X 91.115-26

## **MODEL 262**

## CYLINDER BASE GASKET

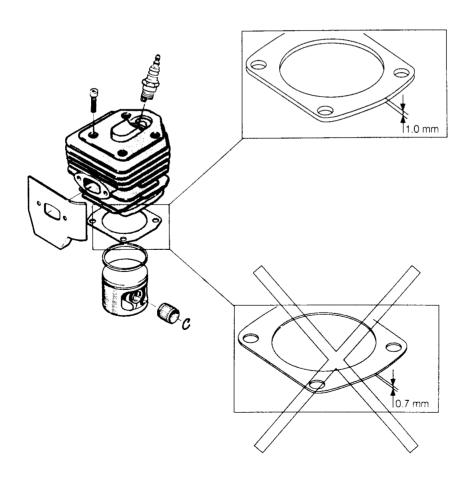
We have in our production introduced a thicker cylinder base gasket. The thickness is increased from 0.7 mm (.028") to 1.0 mm (.039").

The thicker gasket gives an improved combustion and a more stable idling.

New Ref No 501 86 19-03 Description Cylinder base gasket Excluded Ref No 501 86 19-02

Introduced in production from serial no 262 XP -1410514 262 XPG -1410677
